## Duquesne Light

March 5, 1985

SUBJECT: Beaver Valley Power Station - Unit No. 2  
Docket No. 50-412  
PSB Mechanical Responses

This letter forwards revised PSB Mechanical responses which were accepted at a meeting held on February 11, 1985, and an informal meeting held on February 28, 1985. FSAR changes described in these revised responses will be incorporated in an upcoming amendment. The following responses are attached: 430.25, 430.55, 430.59, 430.107, 430.117, 430.122, 430.123, 430.125, 430.126, and GDC 5 for communications systems.

FIG. 430.123-1  
 DIESEL GENERATOR EXHAUST  
 CONFIGURATION

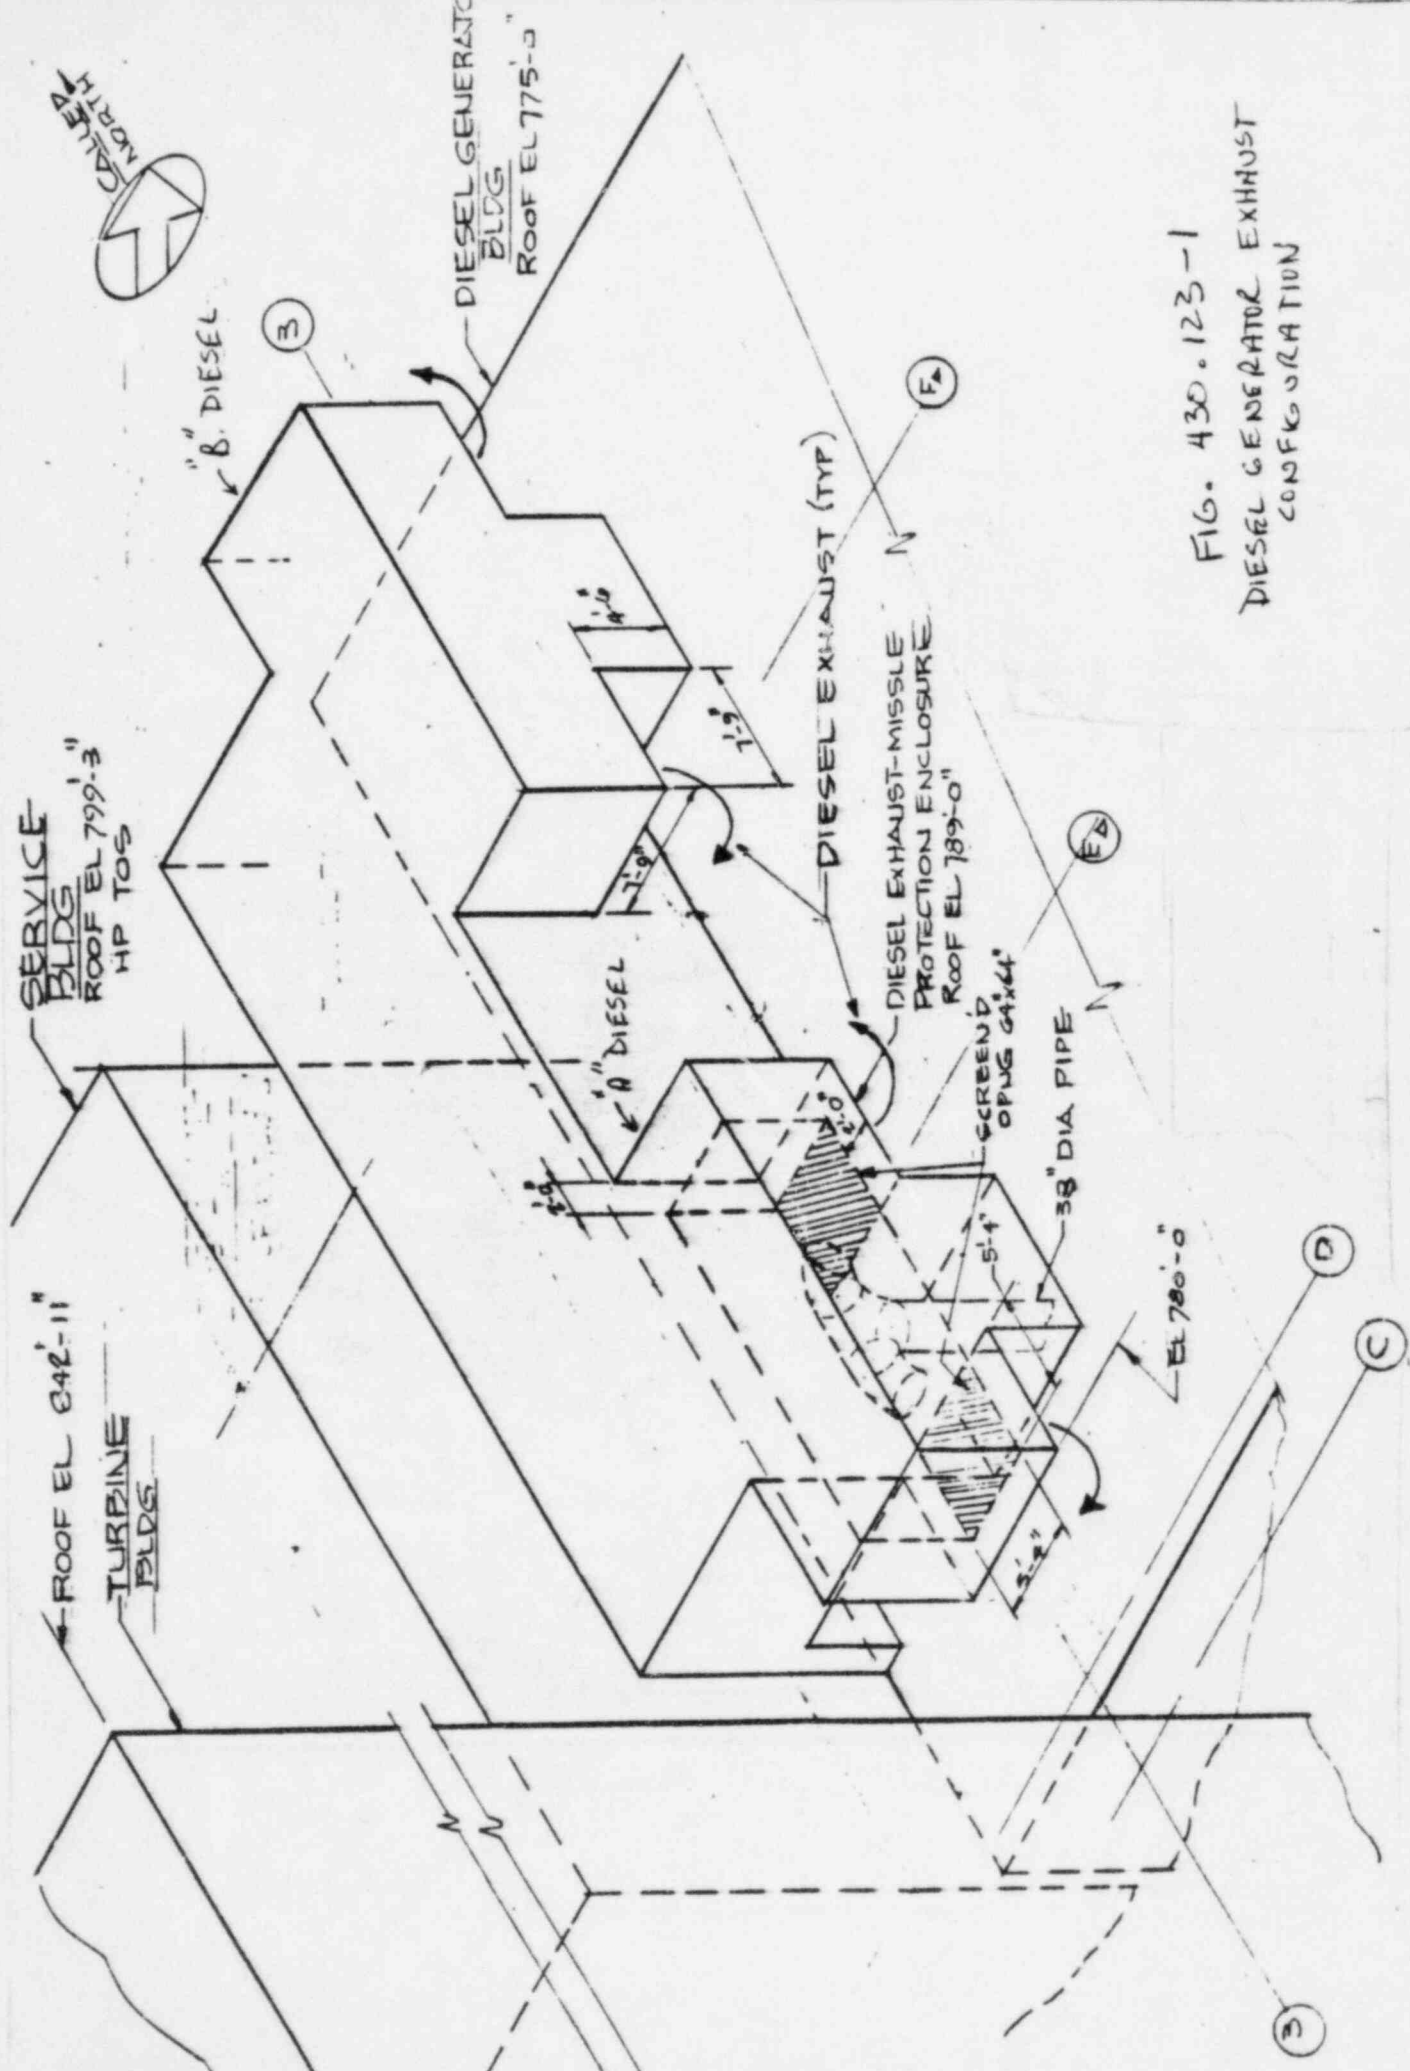
Discuss the provisions made in your design of the diesel engine combustion air intake and exhaust system to prevent possible clogging, during standby and in operation, from abnormal climatic conditions (heavy rain, freezing rain, dust storms, ice and snow drifts, and snow) that could prevent operation of the diesel generator on demand (SRP 9.5.8, Parts II and III). 1.14  
 1.15  
 1.16  
 1.17

Abnormal climatic conditions to be considered at BVPS-2 would include heavy rain, freezing rain, ice and snow drifts, and snow. Heavy rain, freezing rain, and snow cannot impair the functioning of diesel intakes and exhausts because of the downward facing openings of the labyrinths which are designed to protect the exhausts and intakes from tornado missiles. Drifting snow cannot restrict intakes due to their elevation, which is greater than 25 ft. above the ground (refer to Figure 3.8-43). Blockage of diesel exhausts by drifting snow is prevented by the location and configuration of the concrete hoods (refer to Figure 3.8-43). Since each hood has two downward facing openings, one on the north side of the center supporting pedestal and one on the south side of the pedestal, blowing snow from the north or south will not significantly drift at least one opening on each diesel exhaust because of shielding by the pedestals and/or the adjacent diesel exhaust hood. Snow blown from the east or west will not drift significantly because the north opening of the "B" diesel exhaust and the south opening of the "A" diesel exhaust permit blowing snow to freely pass under the overhanging openings. In addition, the area of the openings (over 50 ft<sup>2</sup>) far exceeds the area of the exhaust pipe (less than 8 ft<sup>2</sup>) and would permit significant screen blockage before diesel performance would be impacted. Snow depth can reach 51 inches average at the diesel exhausts and still maintain the 8 ft<sup>2</sup> total opening area, assuming the exhaust flow does not blow or melt nearby snow (which it certainly would). 1.19

IT CAN EASILY BE SEEN FROM FIGURE 430.123-1 THAT WINDS FROM OTHER DIRECTIONS ALLOW CONSIDERATION OF A COMBINATION OF THE CHARACTERISTICS WHICH PREVENT SIGNIFICANT NORTH-SOUTH OR EAST-WEST DRIFTING.
